**LEBANON PLANNING BOARD
APRIL 15, 2024 - 7:00 PM
COUNCIL CHAMBERS, CITY HALL OR
REMOTE VIA VIRTUAL PLATFORM
LEBANONNH.GOV/LIVE**

CITY OF LEBANON ~ PLANNING & DEVELOPMENT

RE: *Agenda Item 3.A – Liberty Utilities Scenic Road Vegetation Management*
April 15, 2024 Planning Board Meeting

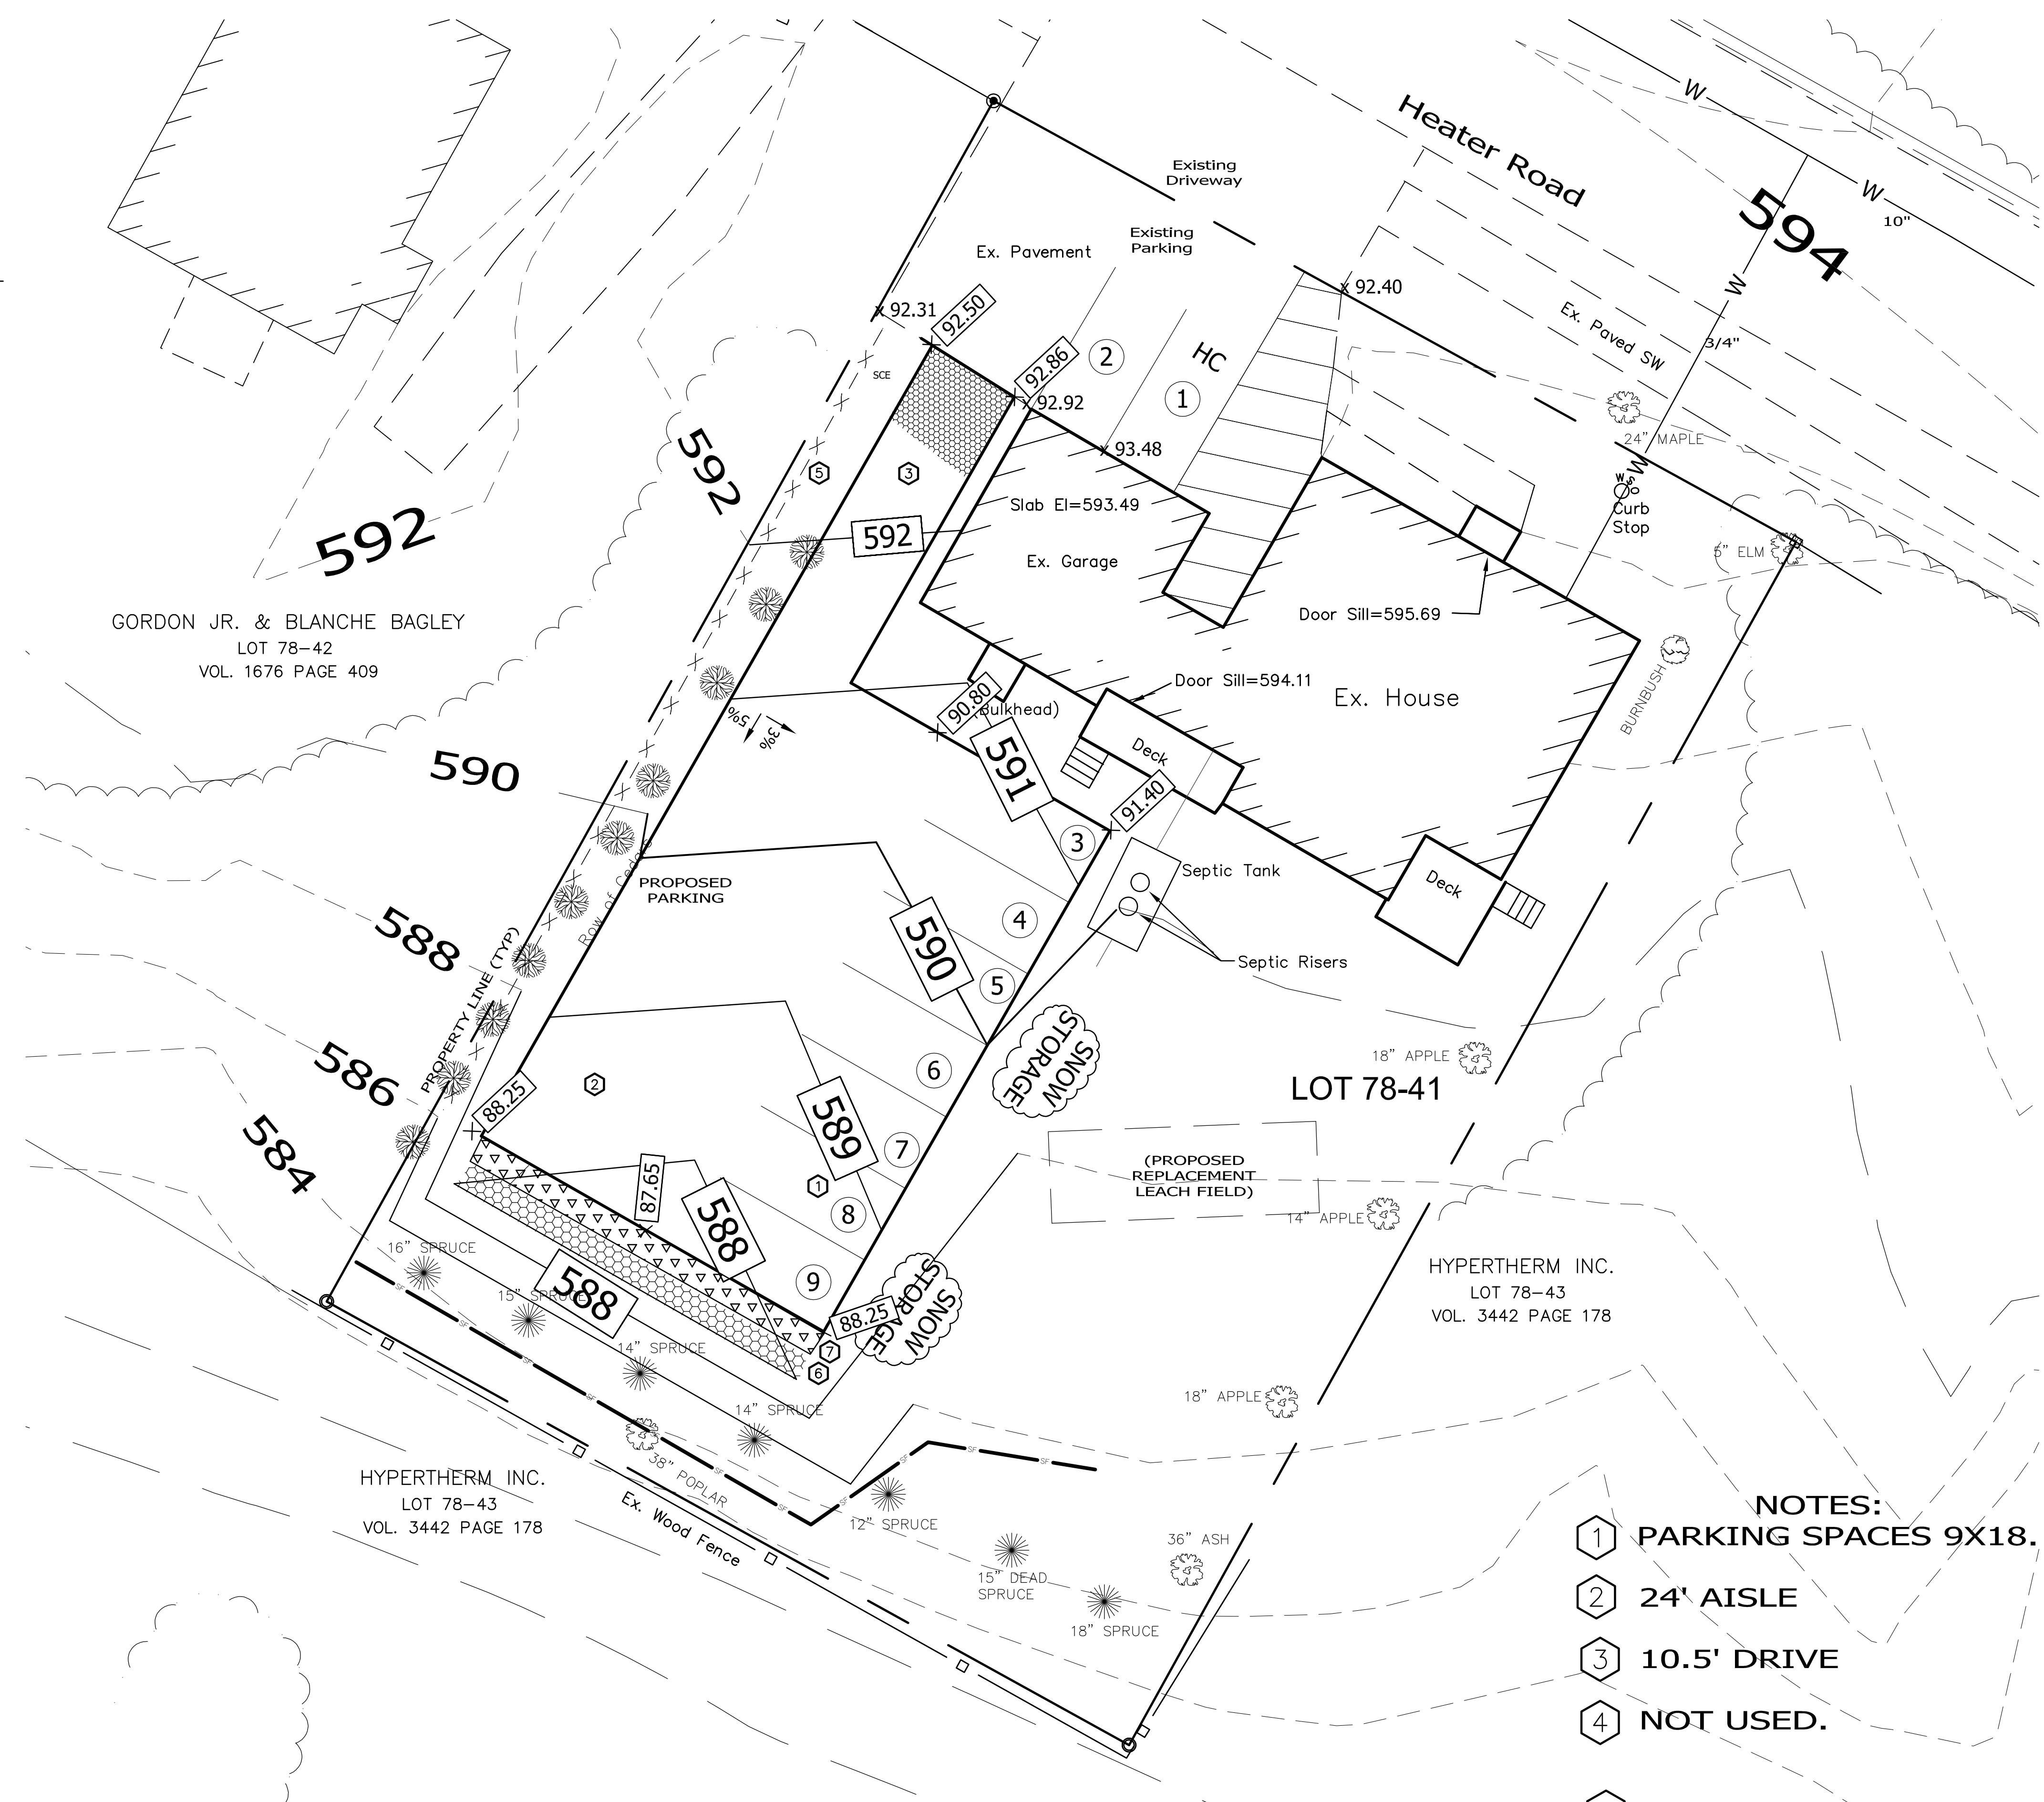
The two (2) spaces for the trailers (which are spaces 8 and 9 as shown on Sheet 5 (C-1) of the plan set) are allowed pursuant to Section 303.4 of the Zoning Ordinance which provides as follows:

The applicant has demonstrated that the proposed outdoor storage space (consisting of parking spaces 8 and 9 as labeled on Sheet 5 (C-1) will occupy an area of 20 percent or less than the building footprint and, therefore, is permitted “by right” without requiring an additional Conditional Use Permit.

- c) On Sheet 5 (C-1):
 - i. add a note identifying how trash pick up will be handled.
 - ii. provide a legend identifying various symbology.
 - iii. identify proposed uses of the existing building (*staff note: instead of "ex. Garage" and "ex house" which would be more appropriate for an existing conditions plan, not a site plan that is intended to depict future conditions*).

1. Existing contours removed.
2. Erosion Control legend added. See Sheet C-3
3. Proposed Use. Proposed use is listed on Cover sheet. It is good engineering practice to indicate existing as well as proposed items on plans.
4. Topo. PE stamp is on Sheet C-1 depicting topography. Except under proposed parking, where staff directed it be removed.
5. Drive aisle. Aisle width reduced.
6. Ramp. Ramp removed.

4. Trench capture. The grading has been revised to capture the entire parking lot. See Sheet C-1.
5. Grading. Grading has been revised. See note 4, above. Revised drain area plan is included in the revised drain report (to be submitted separately)

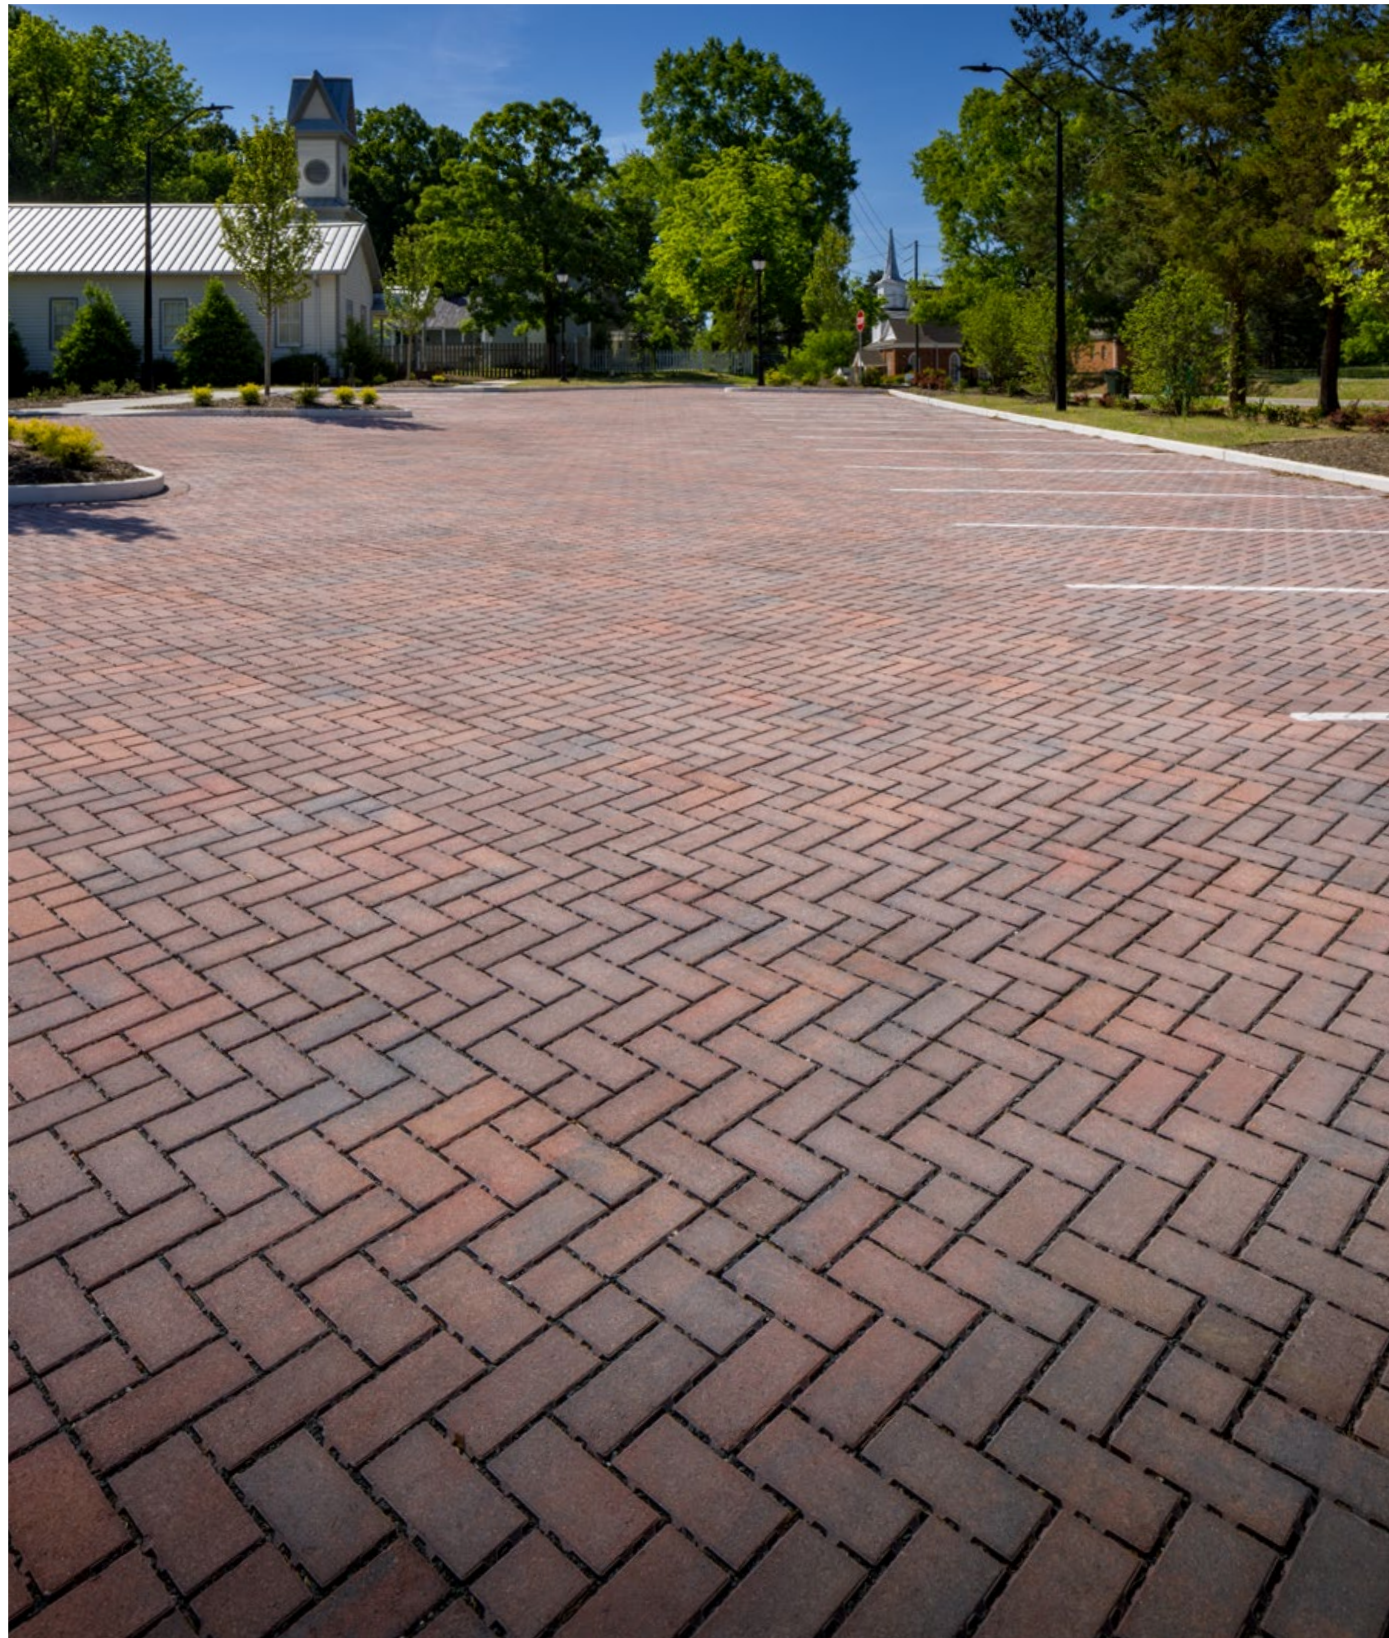
1. Please provide the estimated peak elevation within the proposed infiltration practice for the 10-year and 50-year storms, consistent with Section 6.6 of the Site Plan Review Regulations (SPRR).
2. The proposed stormwater trench volume is noted as 840 cf in the stormwater management calculations. The dimensions of the infiltration trench are 43 feet long by 4 feet deep by 3 feet wide, which totals 516 cf, and with 40 percent void space, the usable square footage would be approximately 206 cf. Please address.
3. The bottom of the infiltration practice has less than 3 feet separation from the estimated seasonal high water table (ESHWT) as is required by Section 6.6 of the SPRR. Please address.
4. The proposed vegetated filter strip minimum width is 25 feet, consistent with Section 6.6 of the SPRR. The proposed filter strip appears to be 3 to 5 feet wide. Please address.

1. The proposed parking lot grading will concentrate stormwater runoff to the center of the proposed infiltration practice. The designer should consider softening the reverse crown of the proposed parking lot/grading to help more evenly distribute the flow.
2. Sheet G-1, Legend, appears to have several elements that are not proposed on this project. Please amend the plan to remove items that are not proposed for this project.
3. Sheet D-5, Erosion Control Details appear to show several proposed BMPs that are not called out on the erosion control plans. Please remove any details or notes that do not apply to this project.

Note: We have changed the Stormwater System to be a pervious paver panel system. The responses reflect this new system in the plans. See Sheet C-2.

L-1

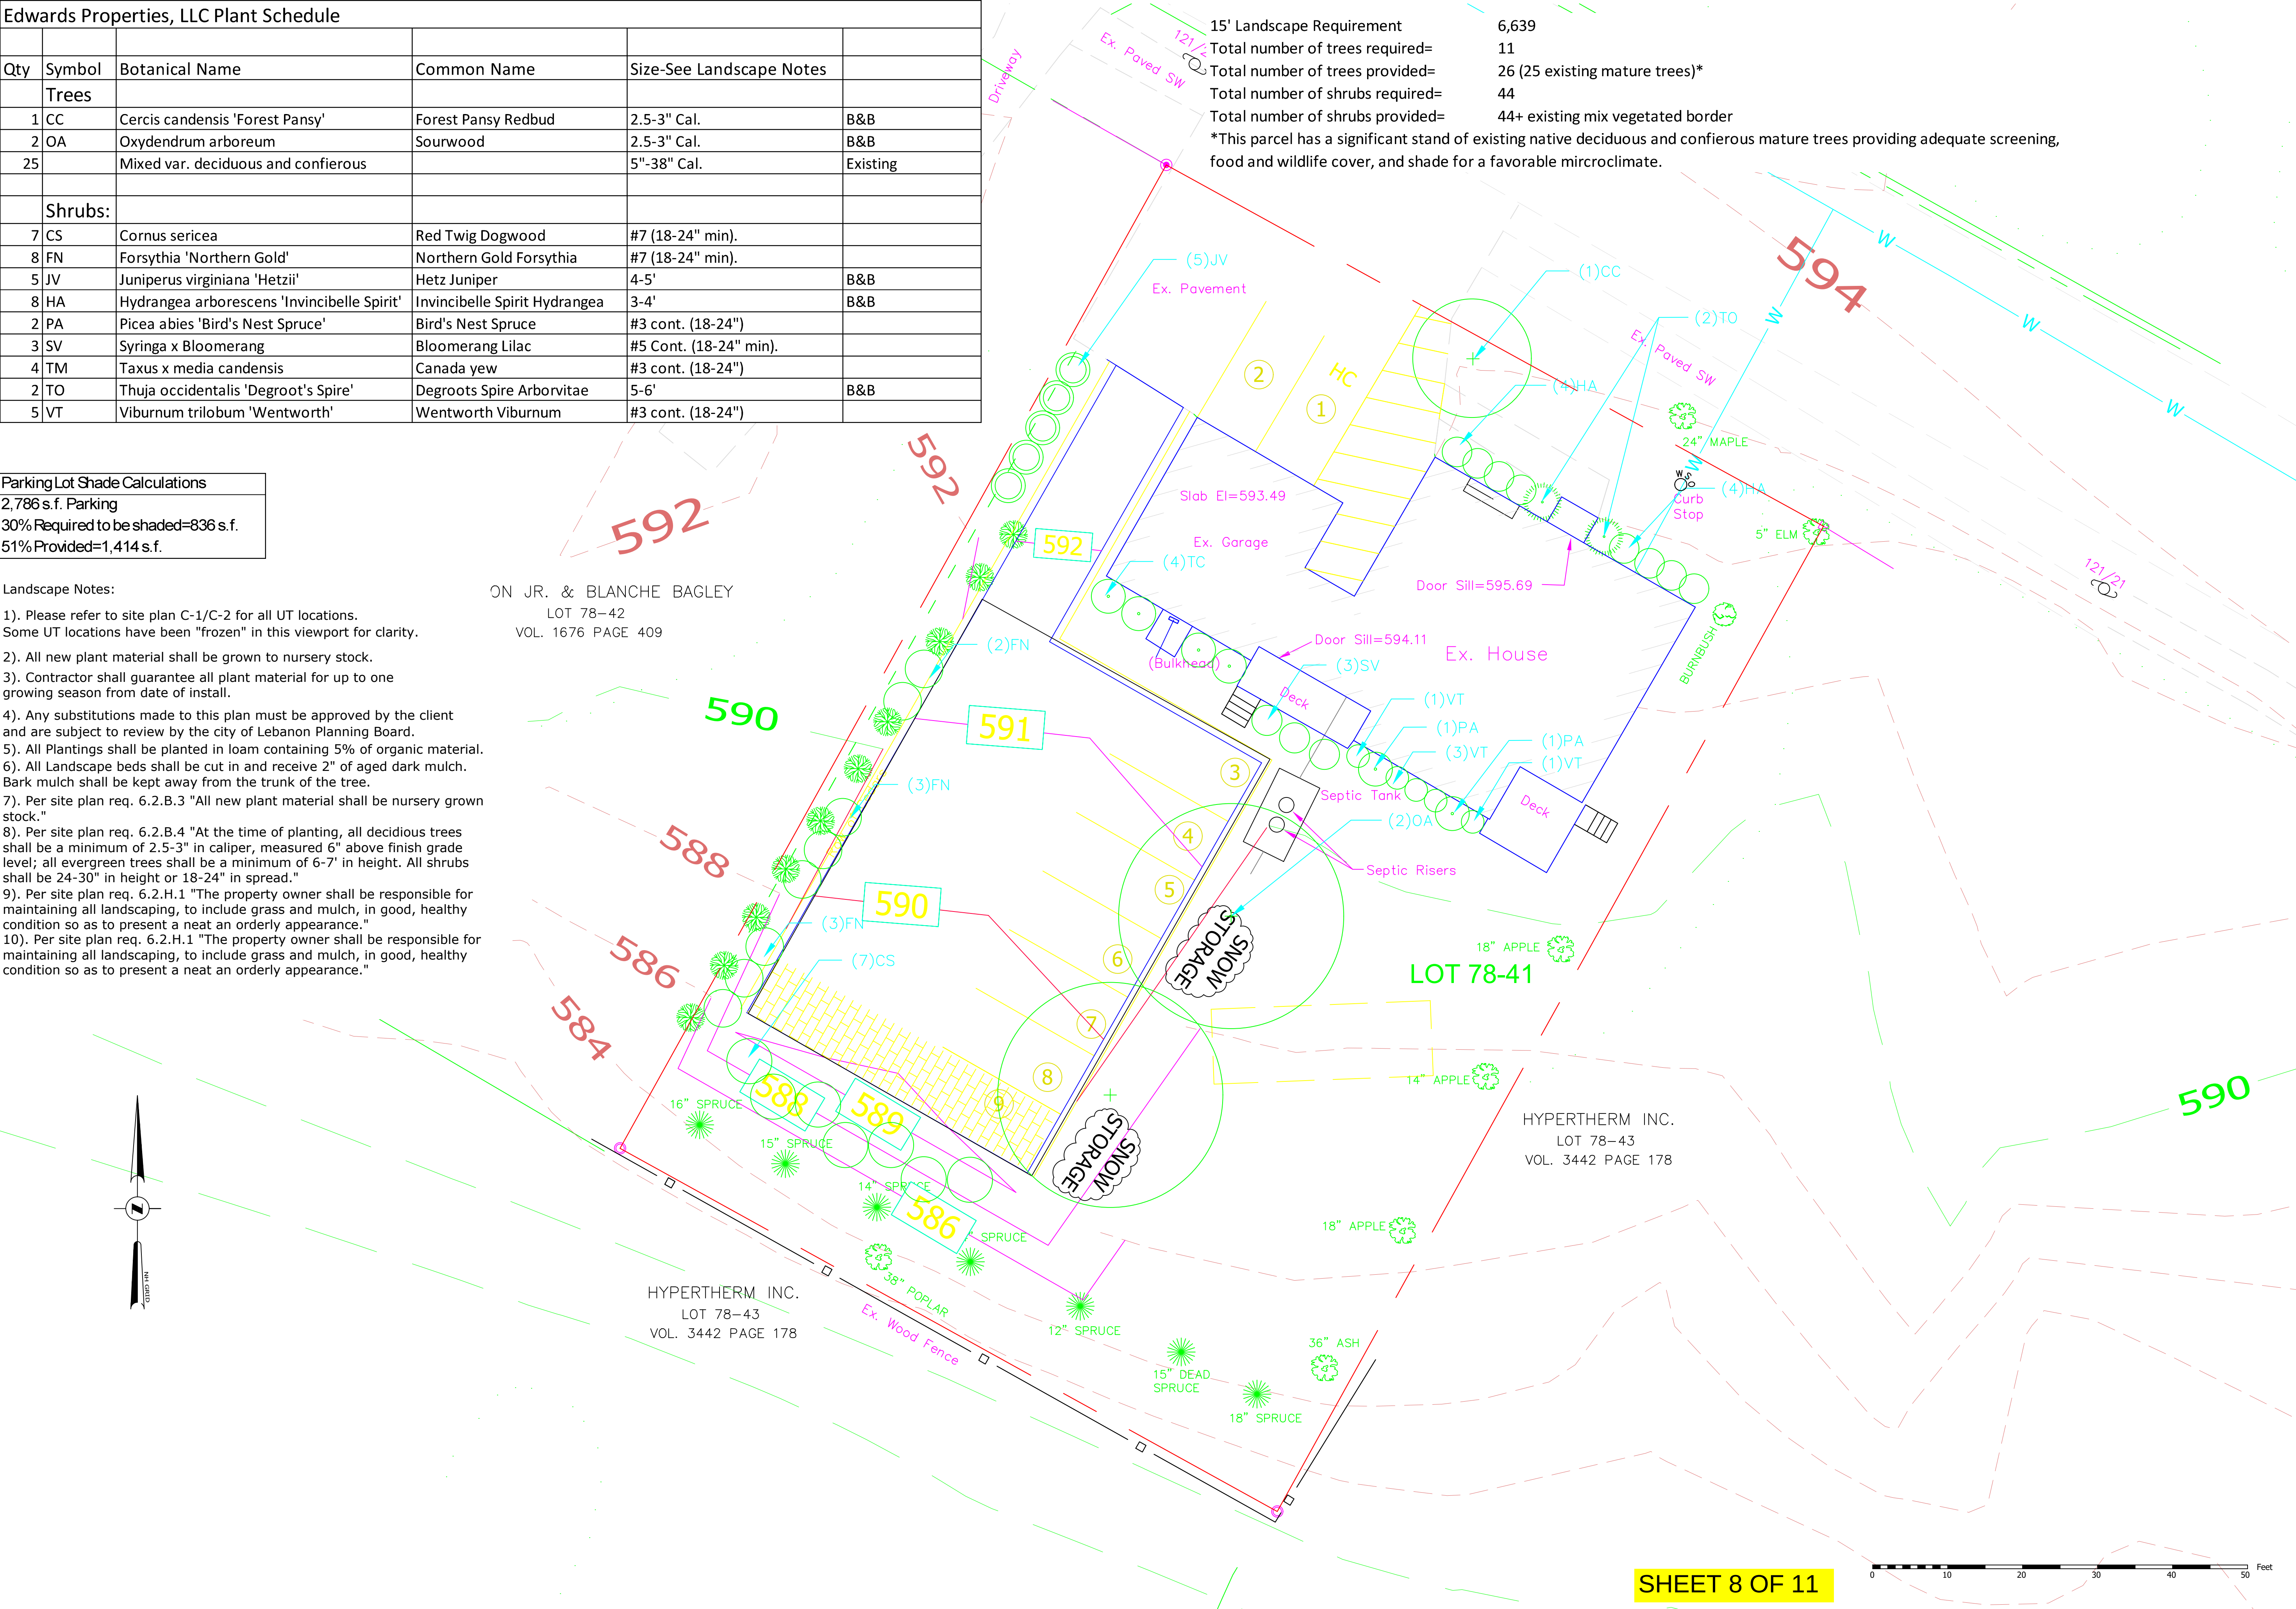
- d) On Sheet 8 (L-1), remove Landscape Note #10 which is duplicative of Note #9.
 - e) On Sheet 9 (L-2), clearly identify the color correlated temperature (CCT) and wattage of the proposed building-mounted light fixture.

2. Landscape Plan. See Sheet L-1.
 3. Landscape Designer. See Sheet L-1.
 4. Landscape Waiver. Waiver will be edited to reflect Sheet L-1.
 5. Road removed. Note: Edwards St still exists with TEE turnaround.

- 6.2.B.1 – The waivers covers areas where the 15’ strip cannot be provided. See revised waivers.
- 6.2.B2 & 3 – The mix of vegetation is provided. See Sheet L-1.
